Access Compliance Report

Public Rights-of-Way

(Curb Ramps)

Intersection ID: 13754		Main Street: S_MCDOWELL_ST		Cross Street: BAXTER_ST		Location: NE			
ADA ID: 65A0011D1166		Ramp Type: Perpendicular		Initial Pass/Fail: Fail		Overall Compliance: No		Severity Score: 37.5	
Codes/Mitigation Info/Possible Solution					Field Measurements/Component Compliance

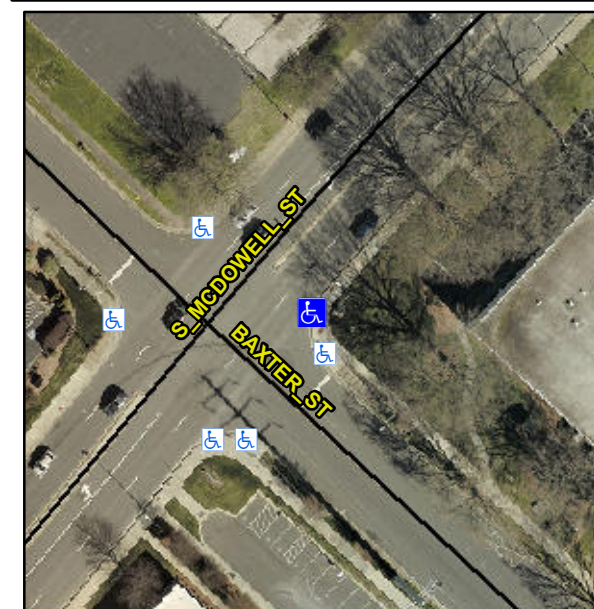
Possible Solutions:

Remove & Replace Entire Ramp.

Not Found, R304.2.2, R304.5.3
